PLANNING AND DEVELOPMENT DEPARTMENT
BRIEF TO PUBLIC HEARING, MONDAY JULY 28, 2025

ITEM #1 – PROJ 22-097 – BYLAW NOS. 5466, 2025 and 5456, 2025

Application to amend *City of Coquitlam Citywide Official Community Plan Bylaw No. 3479, 2001* to redesignate the western portion of the property at 1145 Inlet Street from Medium Density Apartment Residential to High Density Apartment Residential and permit the construction of a 29-storey market strata tower on the western portion of the site (*Bylaw No. 5466, 2025*).

Landscape Site Plan Greenway Diagram

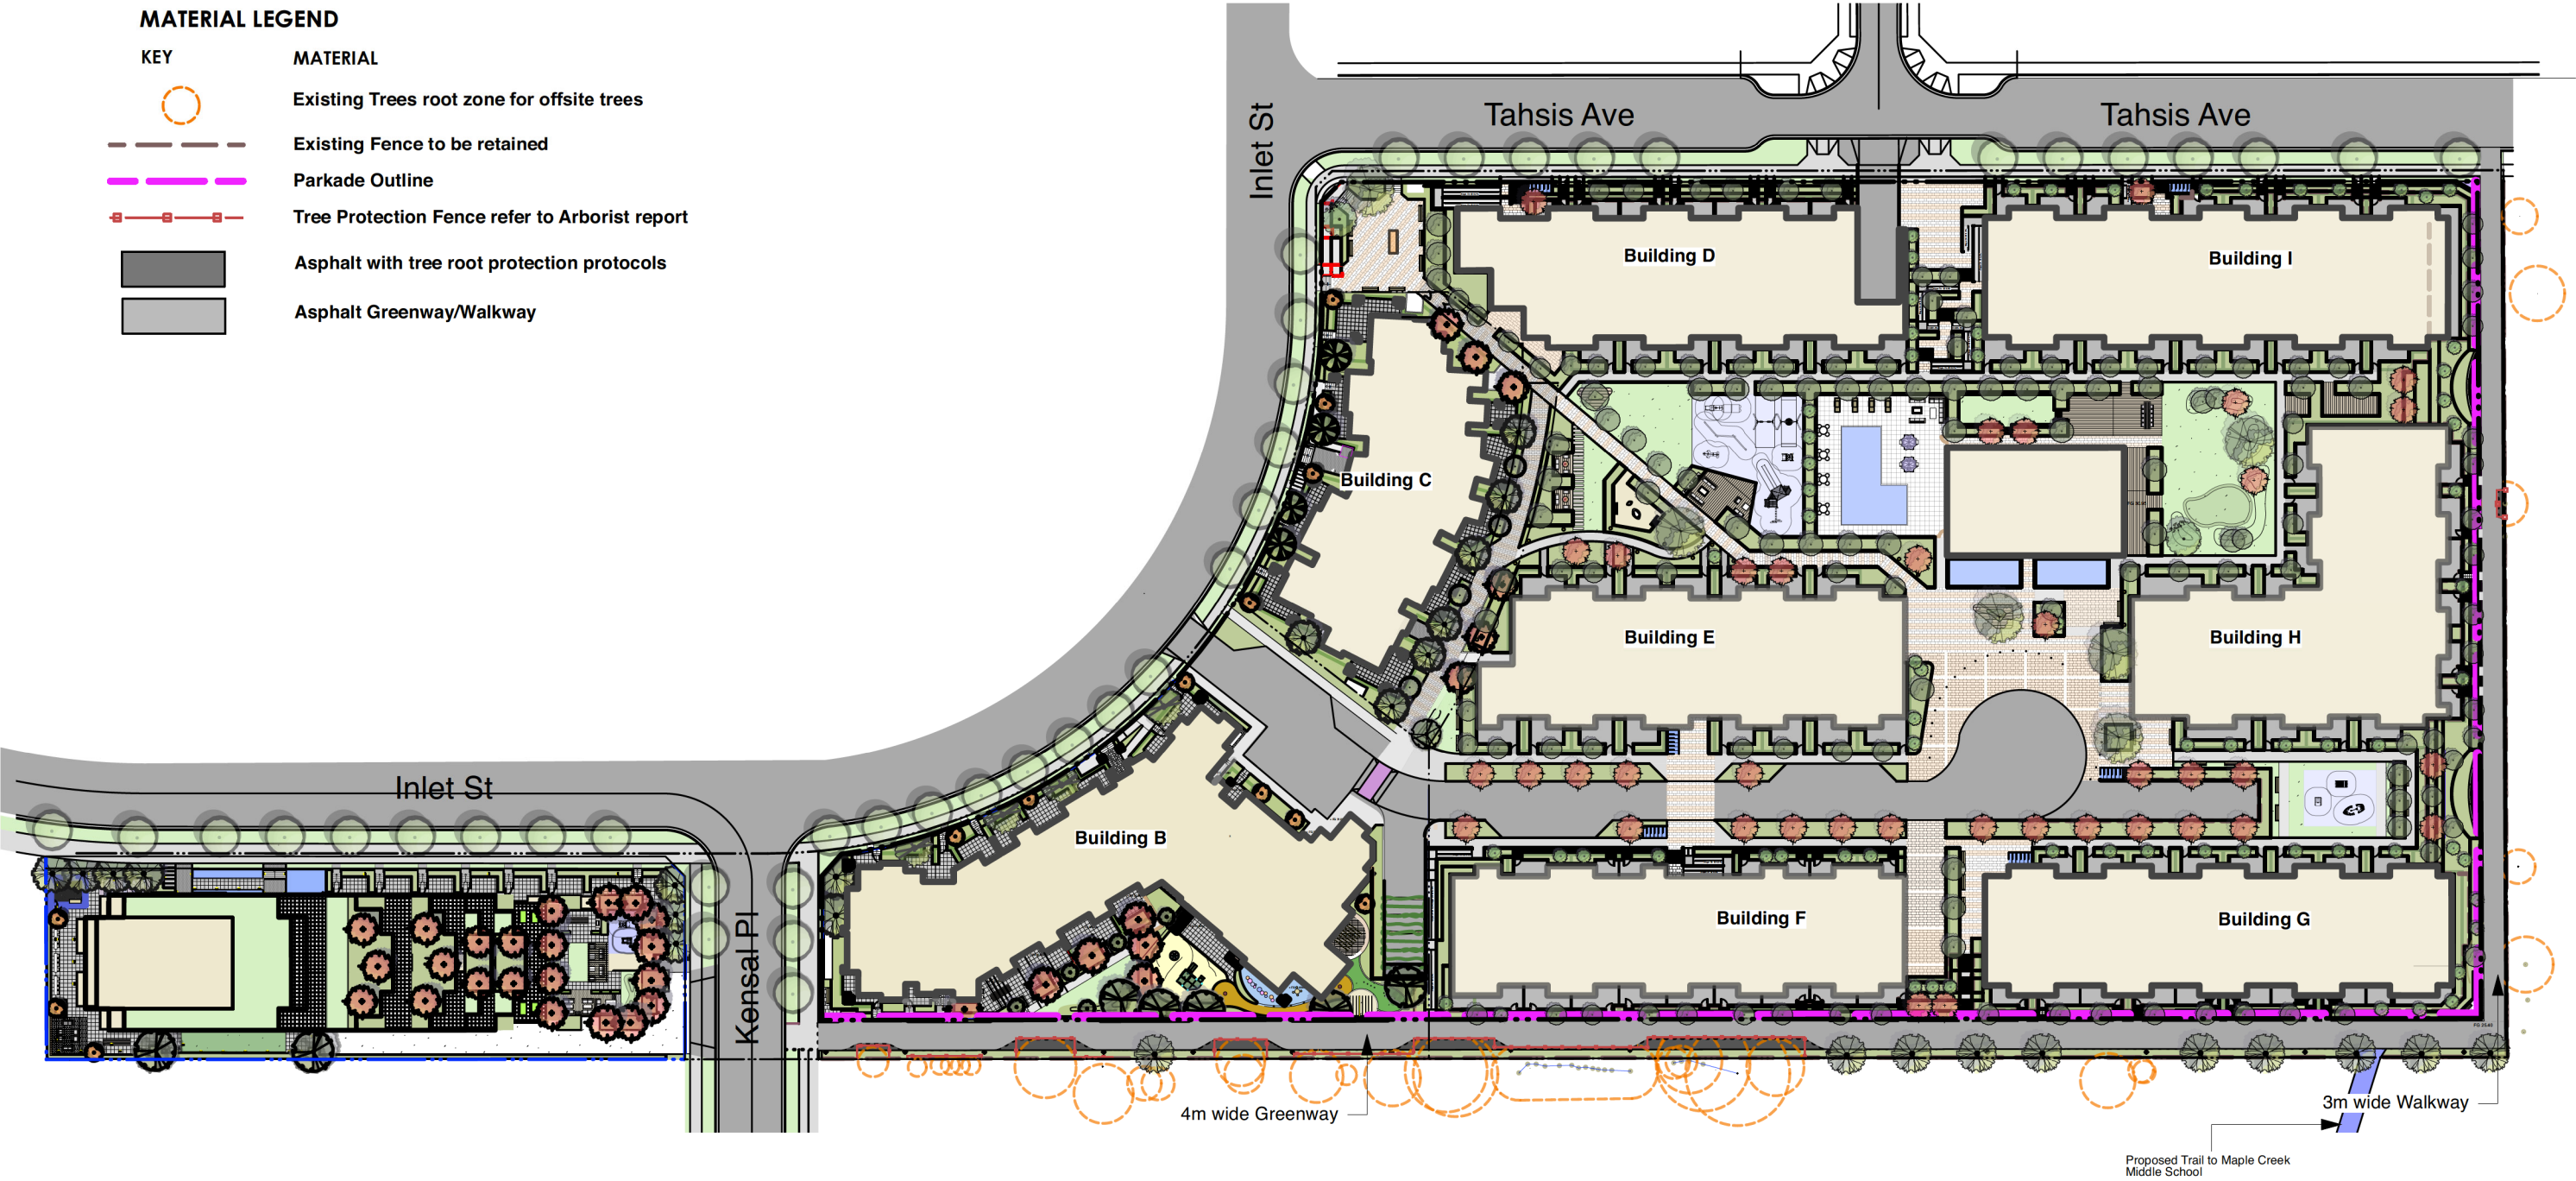
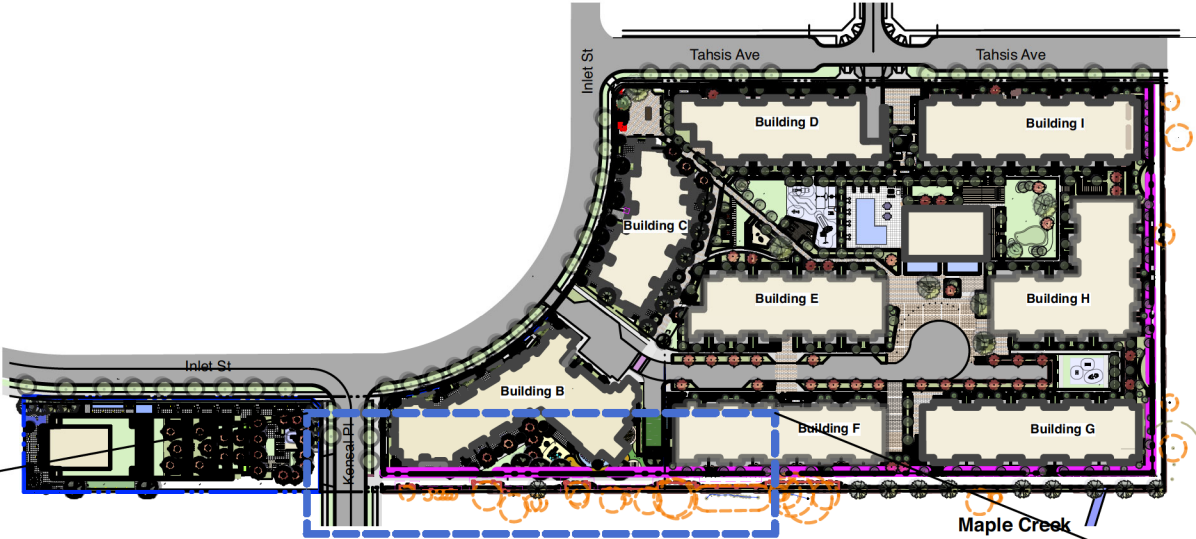
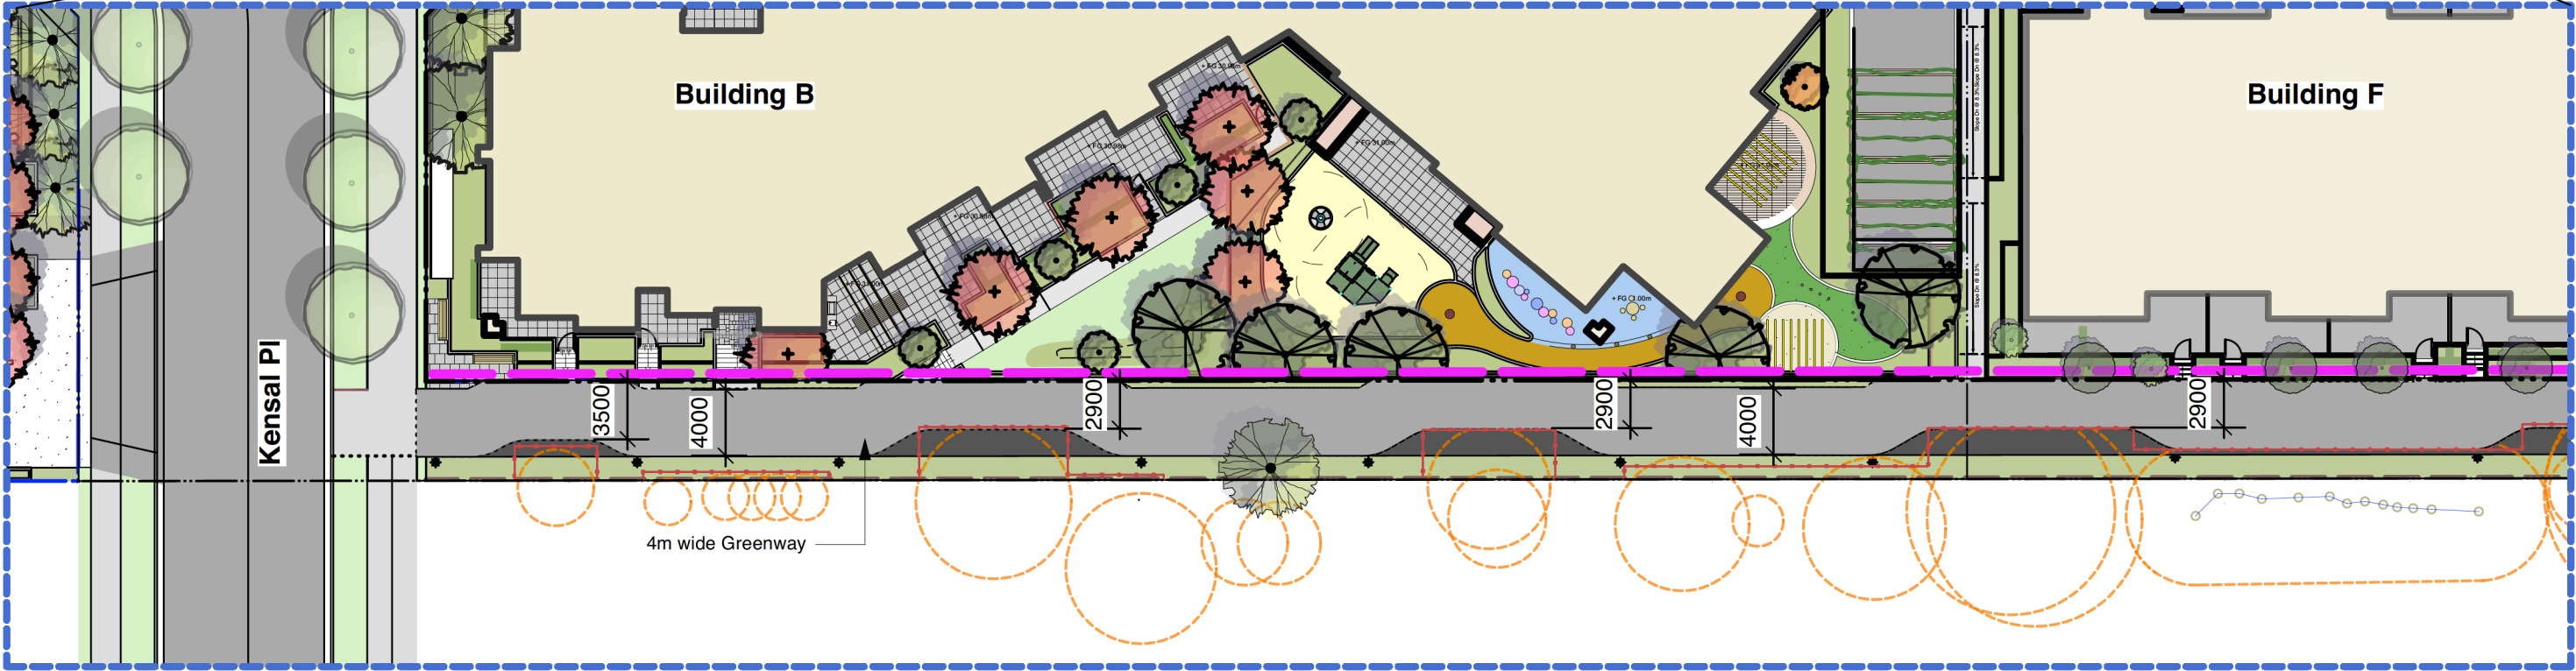
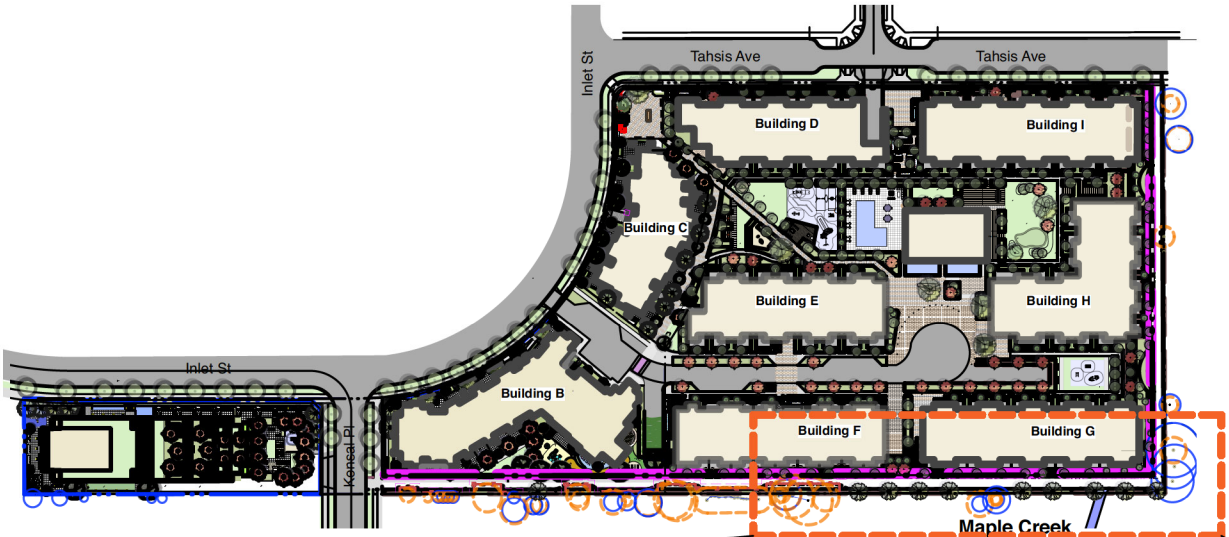
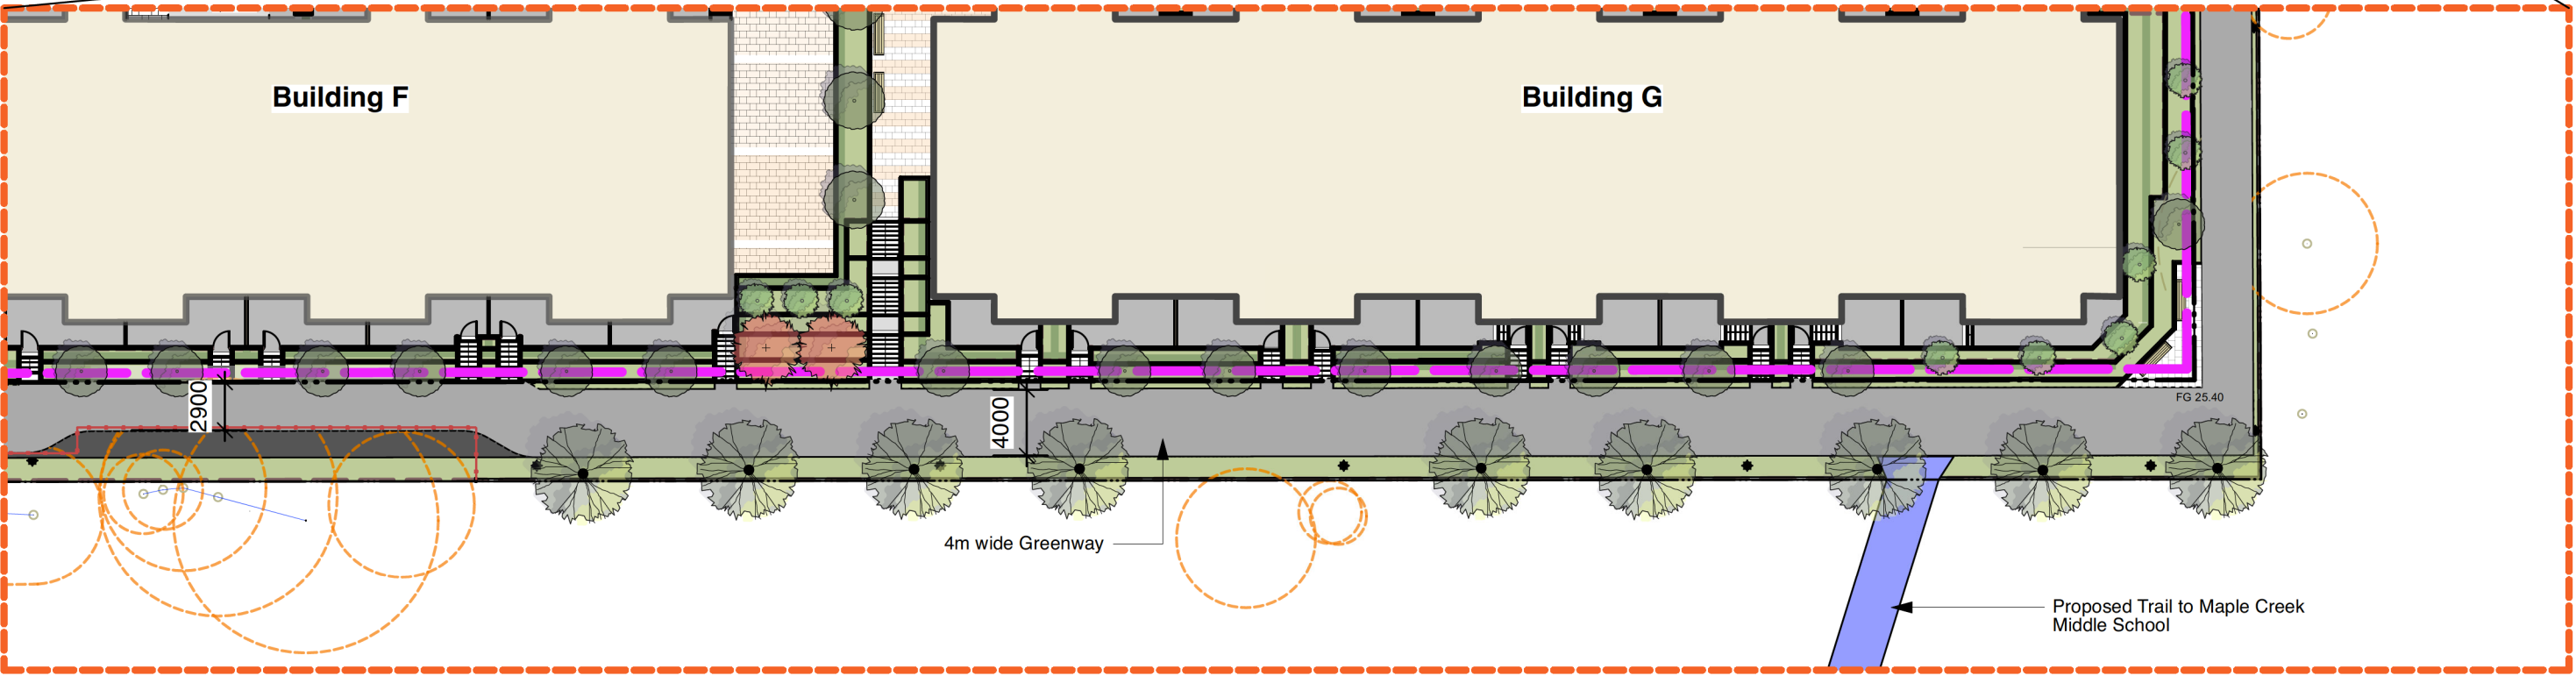
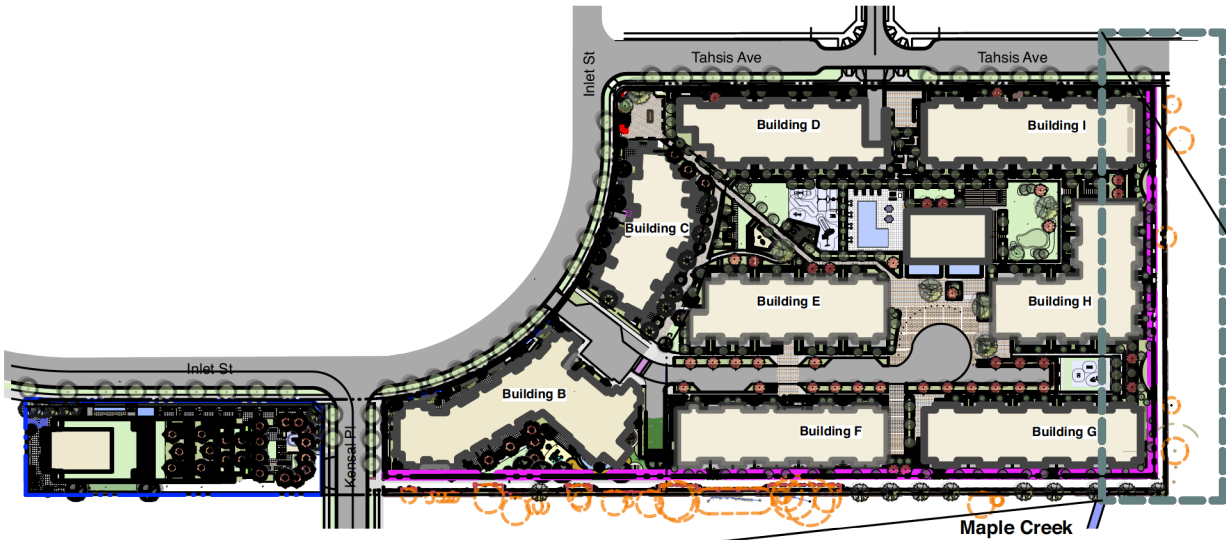
- Use of “low-impact” construction methods with no compaction or excavation: While the recent arborist report includes a general schematic of “Low Impact Pathway Details”, it does not provide specific details on how this would be achieved for each section of the greenway and walkway. Detailed review of this method is required to ensure it will not result in damaging the trees and causing future liability issues for the City. Staff are also concerned about a higher ongoing maintenance cost of this option which will be borne by the City.
- Meandering pathway design which results in a reduced travel width of 2.9 m in some portions compared to the City standards of 4.0 m for the southern greenway. (Attachment 2, pages 2-3)

Should Council grant third reading, staff will continue to work with the applicant to find a workable solution for the greenway and sanitary line. Noting that potential solutions include shifting the buildings to provide sufficient room for the greenway and sanitary line, obtaining consent from adjacent owners to remove trees, or alternatively varying the standards for the greenway or walkway. Shifting the buildings is the preferred approach, however, this may result in amendments to the setback requirements of the CD zone from the southern and eastern property lines after the third reading. The pre-requisites of final reading that were identified in the First Reading Report include resolution of the greenway alignment and considering the interface of the buildings and the walkways.
